# 6 MG CELESTIAL ROAD GROUND STORAGE TANK

TOWN OF ADDISON  
 DALLAS COUNTY, TEXAS  
**6 MG CELESTIAL ROAD STORAGE TANK**

# ONE 6.0 MILLION GALLON WATER STORAGE TANK CONTRACT NO. 86 PE 004 WITH TOWN OF ADDISON, COUNTY OF DALLAS, TEXAS CONSULTING ENGINEERS: GINN INC.

**SITE PLAN**

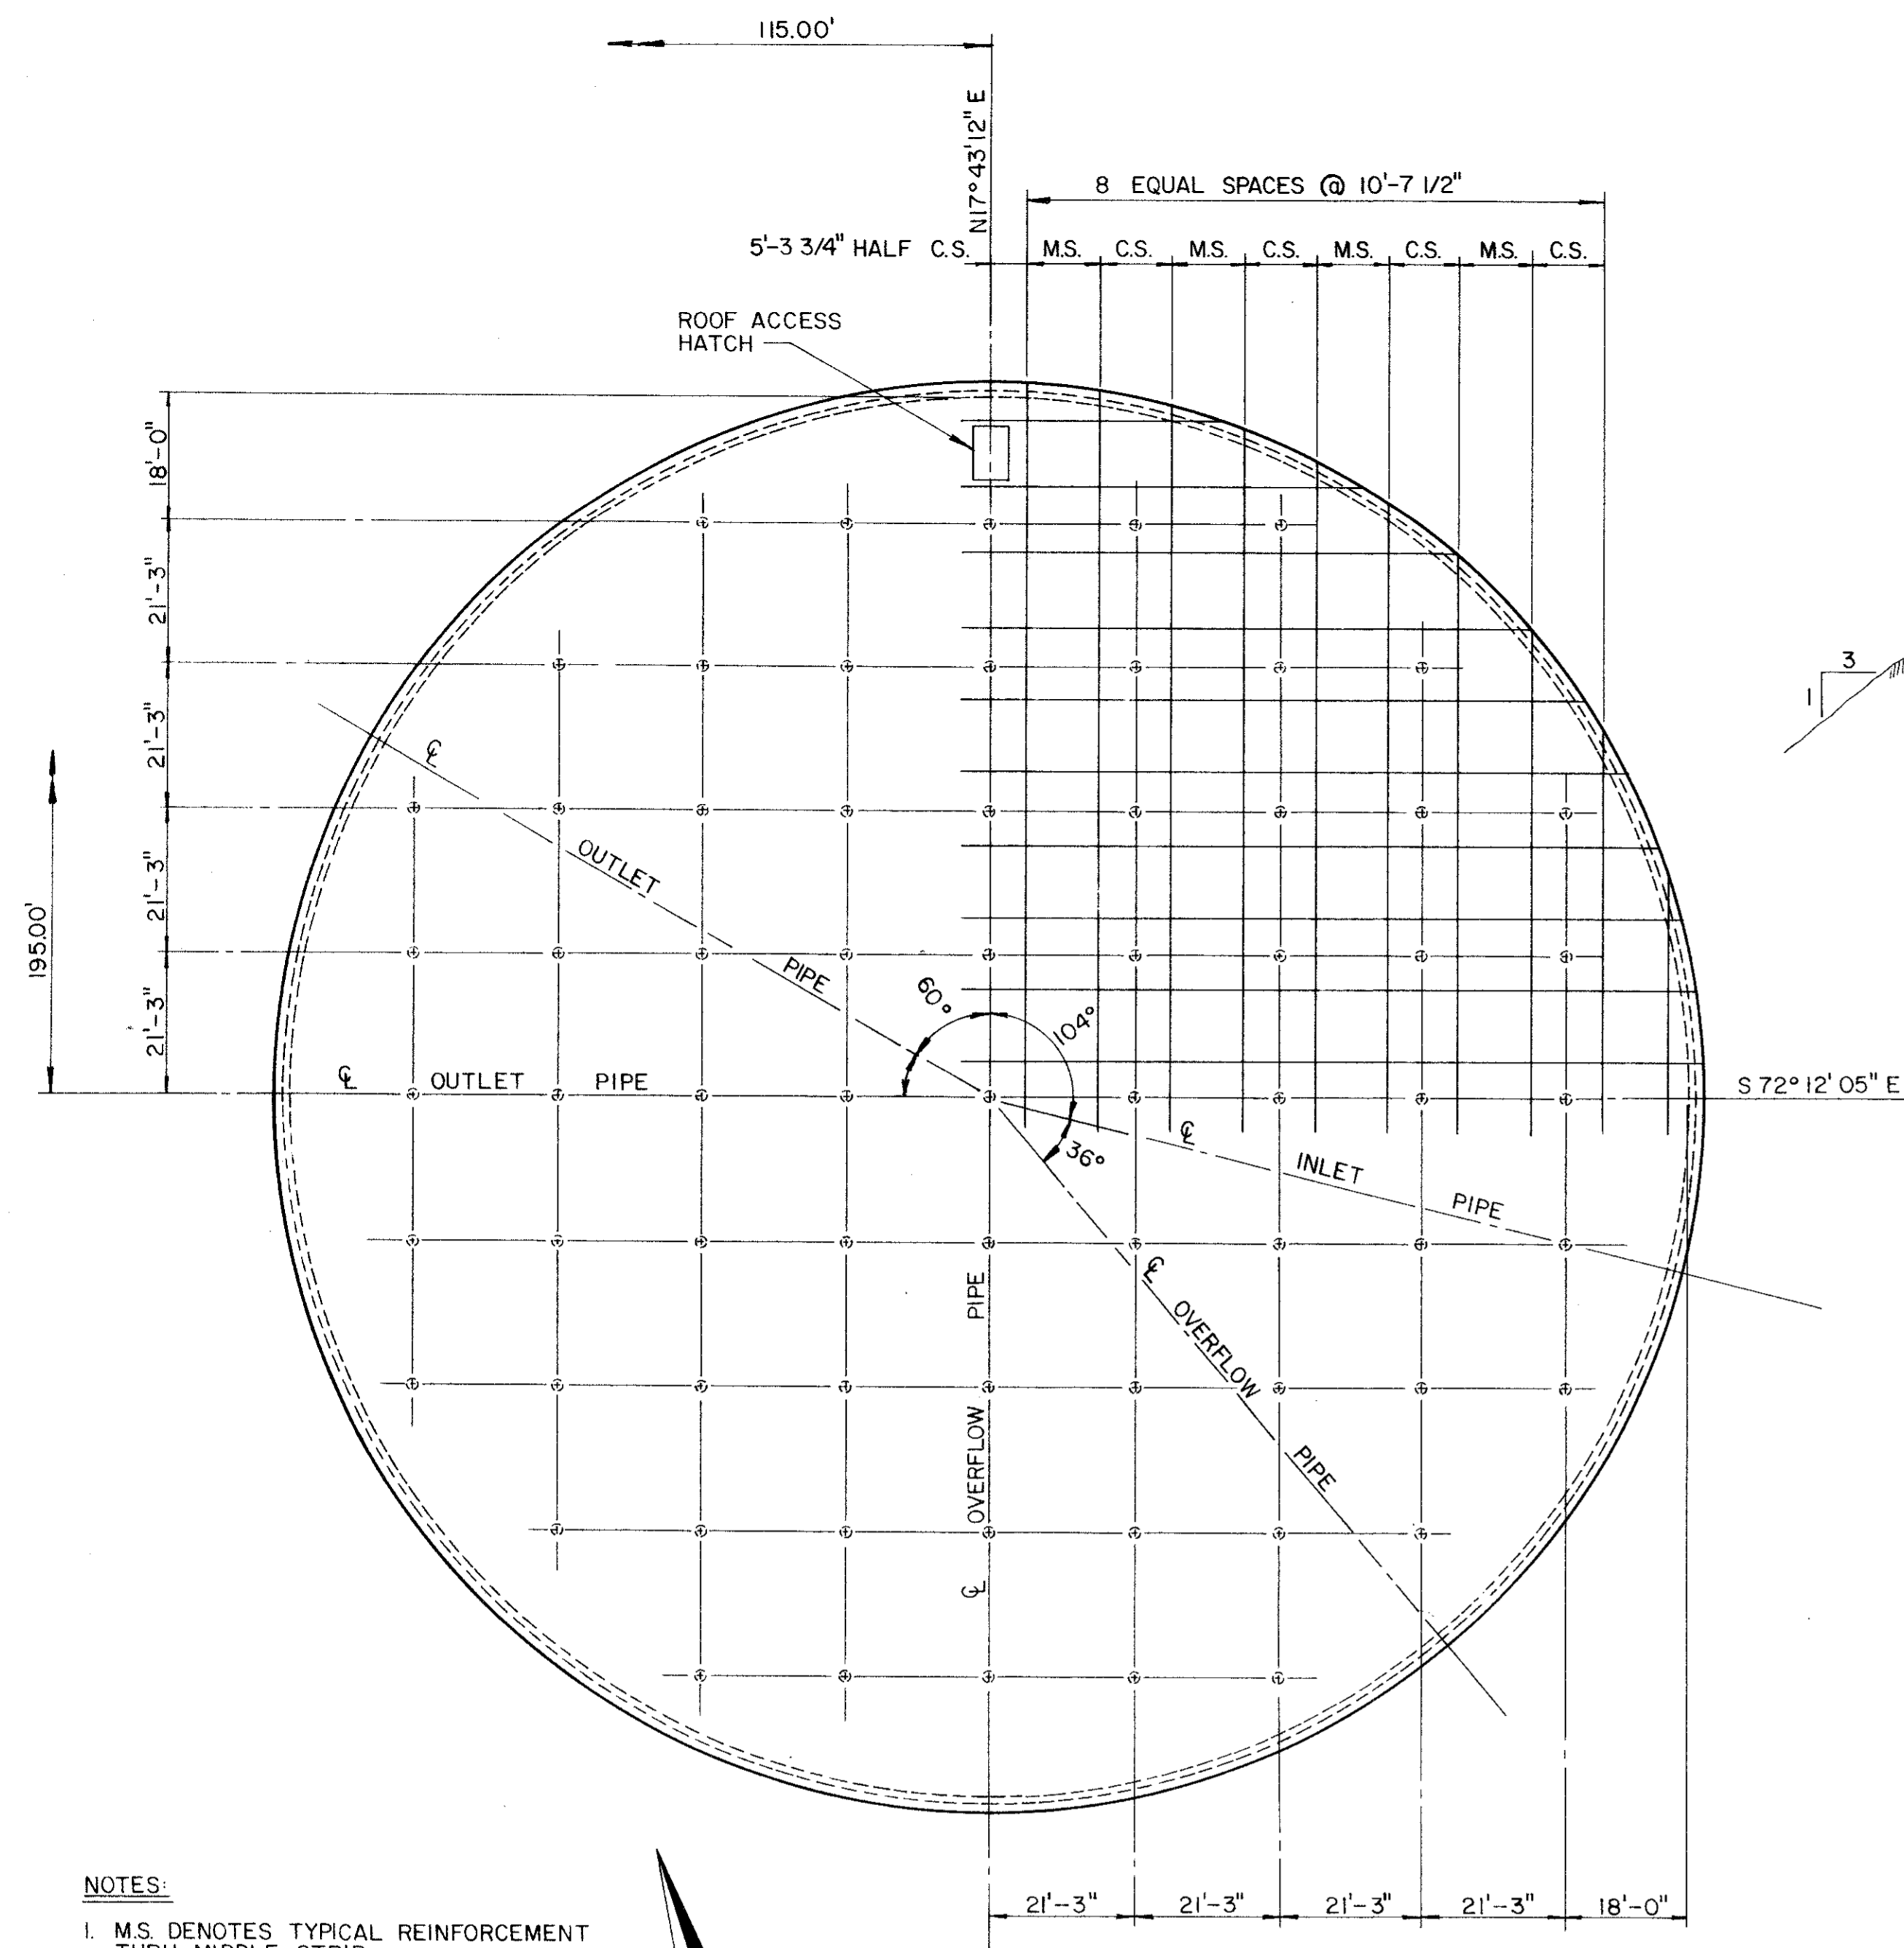
ADD TANK PERIMETER DRAIN ELEVATIONS

ELEVATION (LOOKING WEST)  
N.T.S.

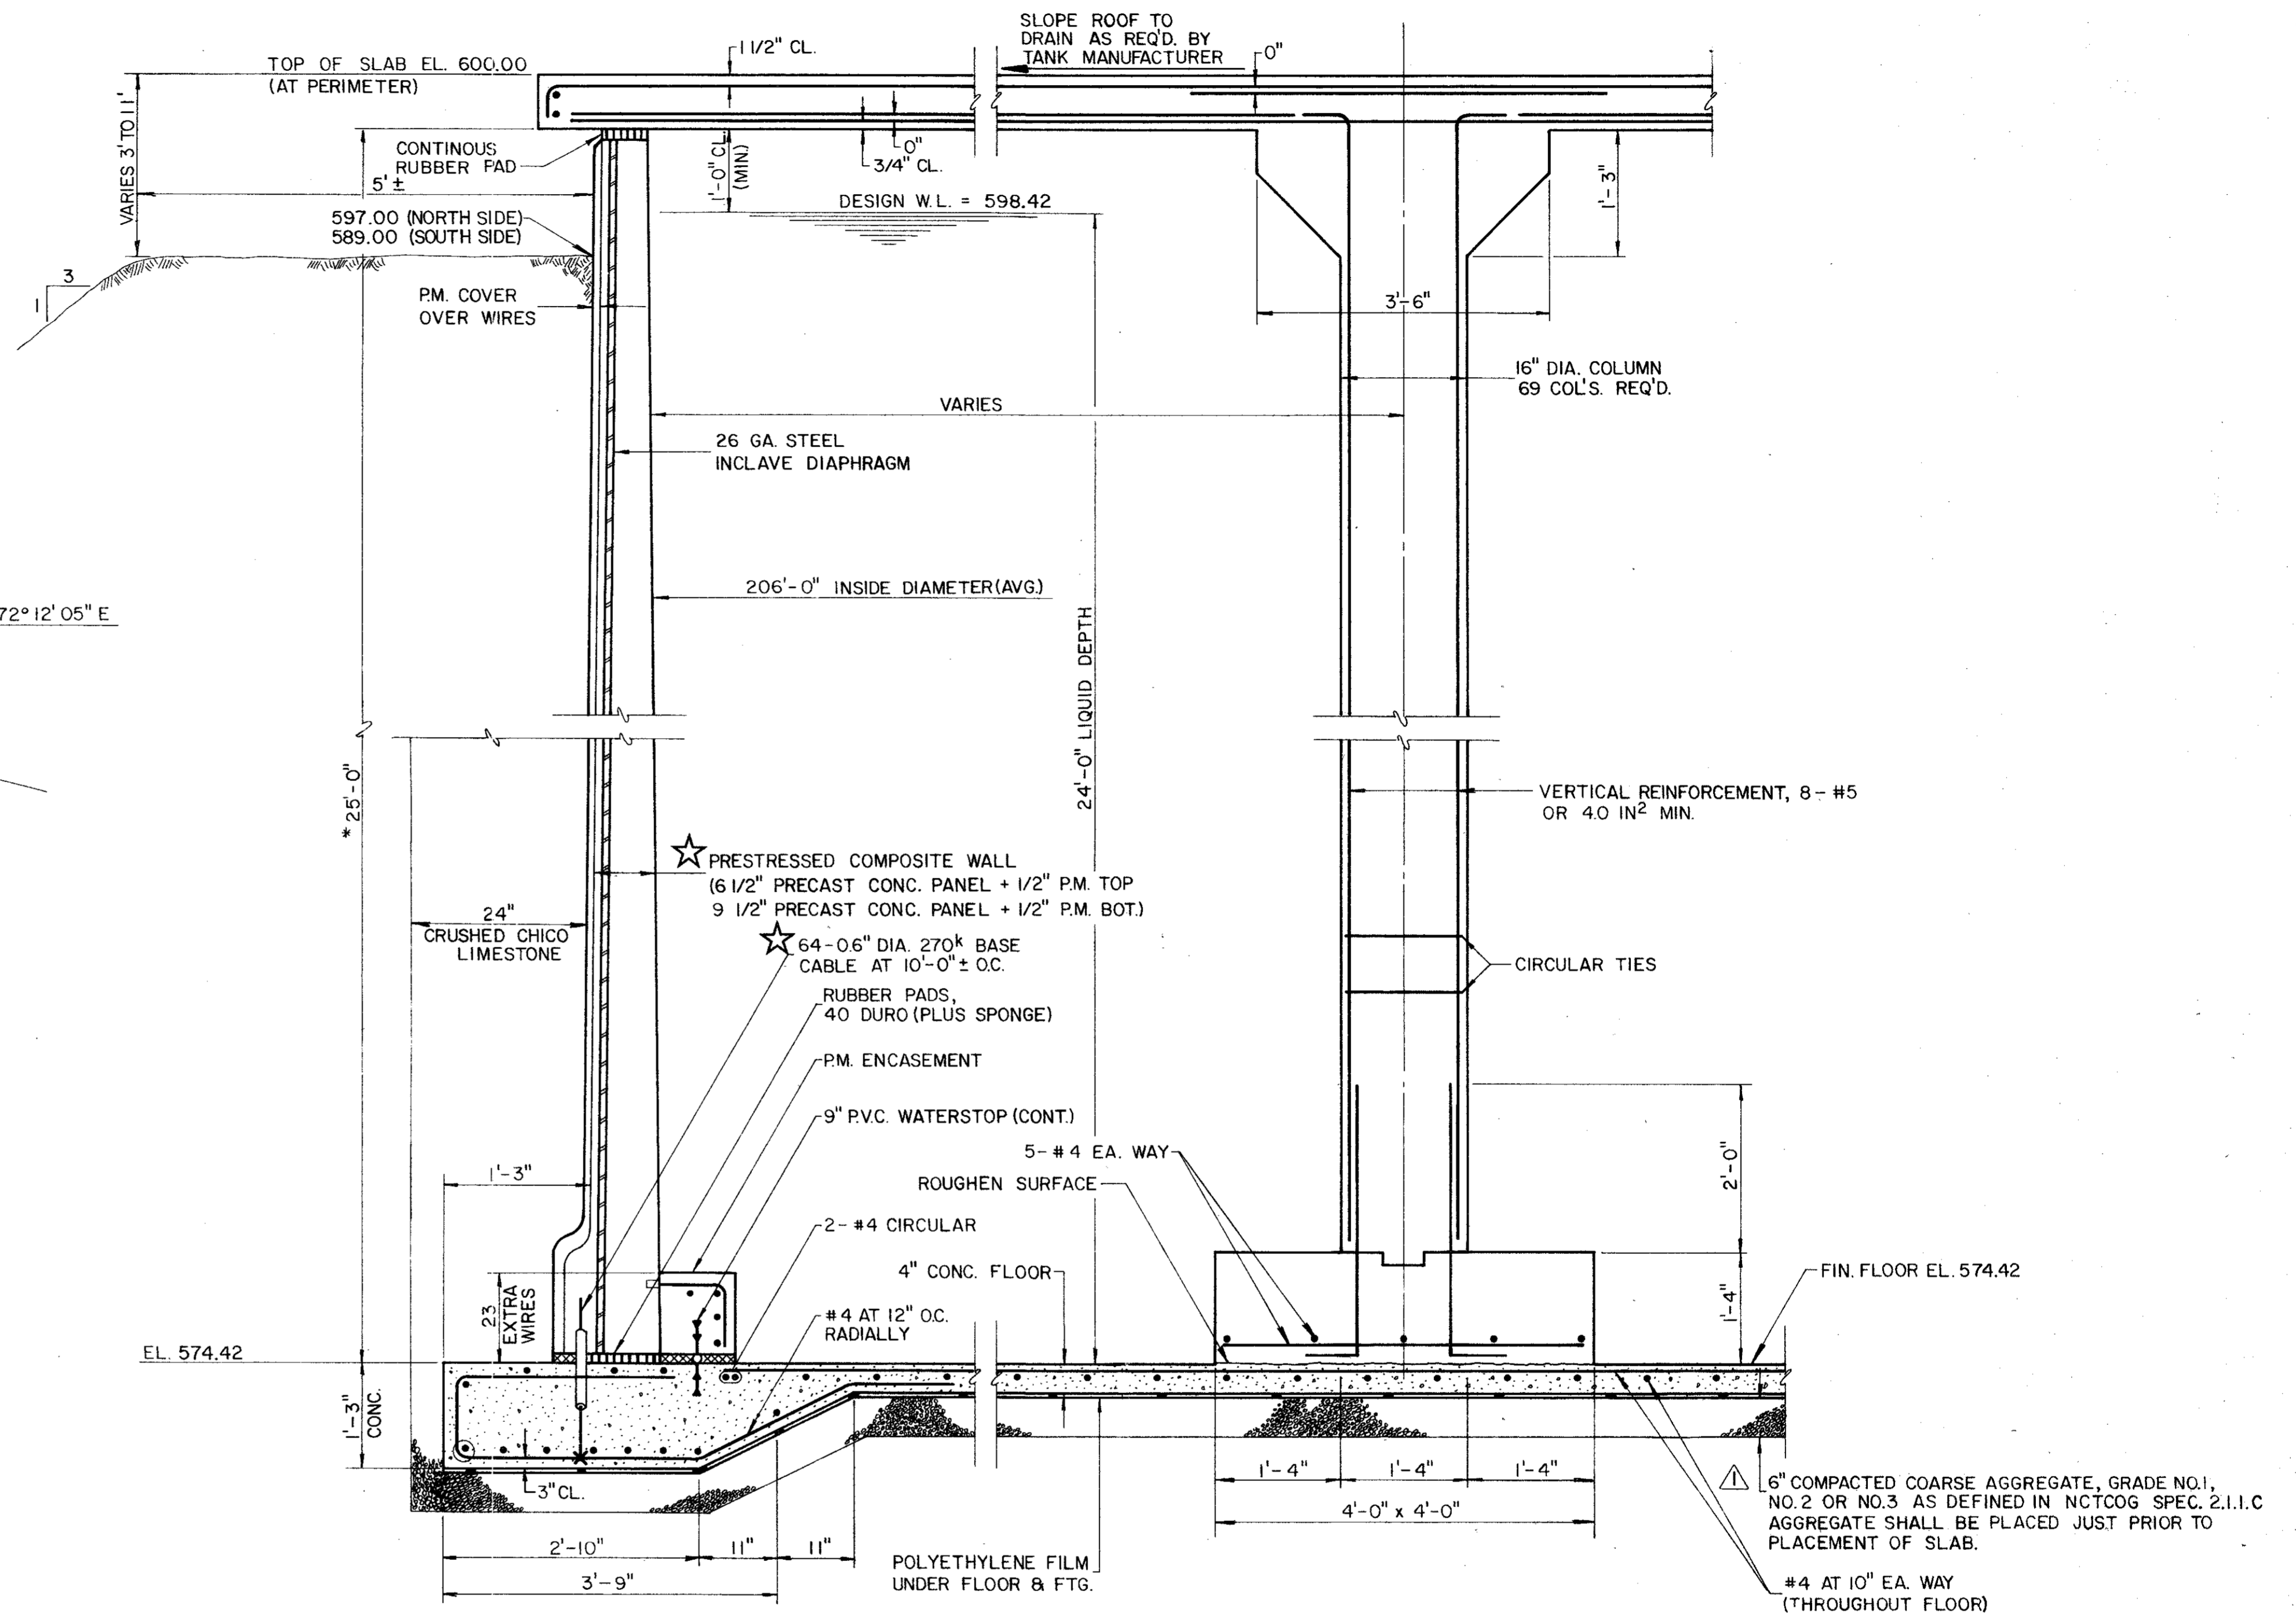
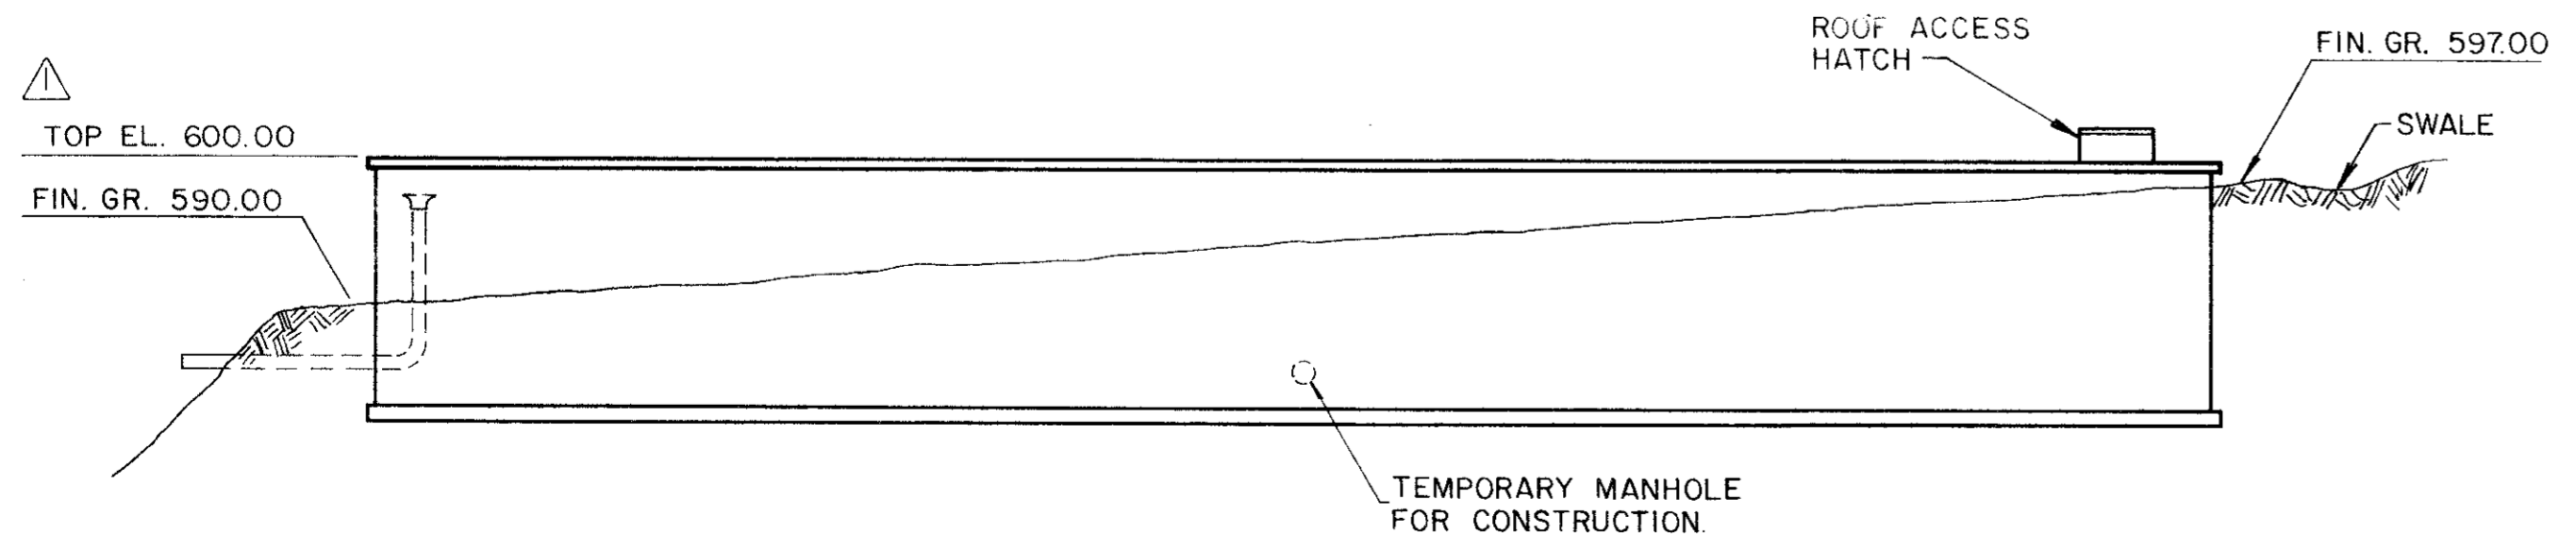
REVISE TOP OF TANK ELEVATIONS		RCH	5-7-86
No.	Revision	By	Date
TOWN OF ADDISON DALLAS COUNTY, TEXAS			
<b>6 MG CELESTIAL ROAD STORAGE TANK</b>			
<b>PLAN AND SECTIONS</b>			
GINN, INC. Consulting Engineers Dallas, Texas			
Designed - RCH	Drawn - ALA	Date - FEB, 1986	Job No. - 215
Approved - HWG	Checked - GF	Scale - AS SHOWN	Sheet 2 of 8

OUTLET PIPE DETAIL

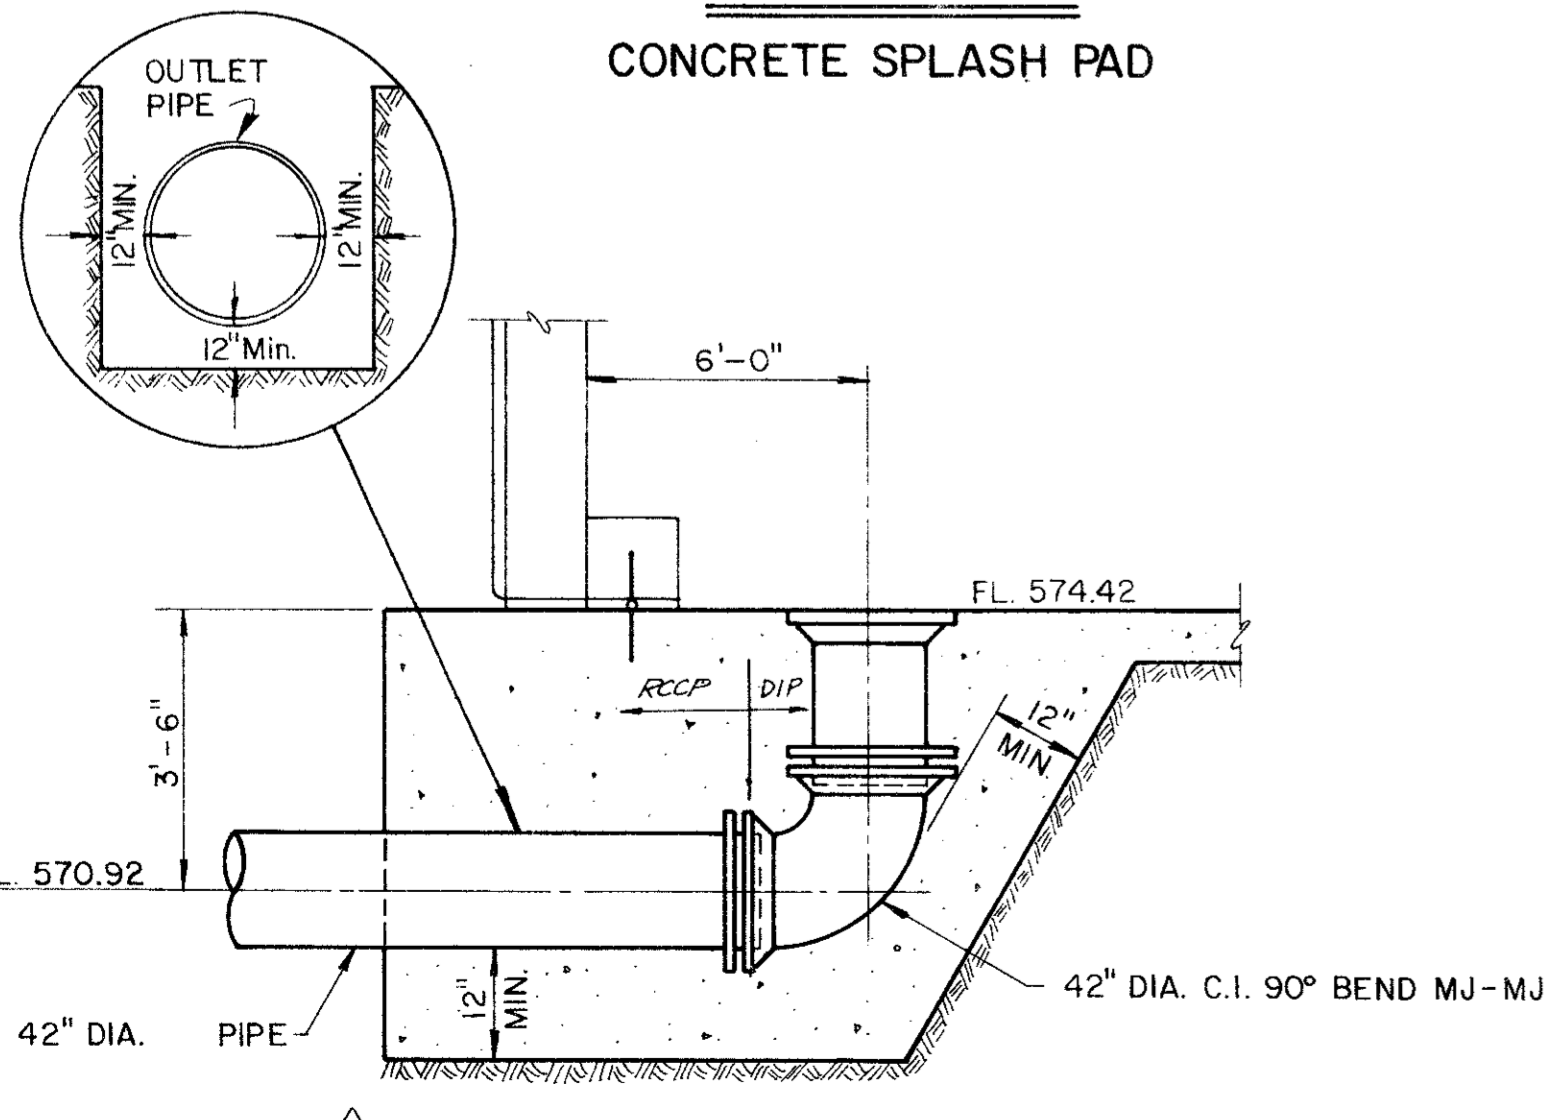
CLARIFY OUTLET PIPE DETAIL			
No.	Revision	By	Date
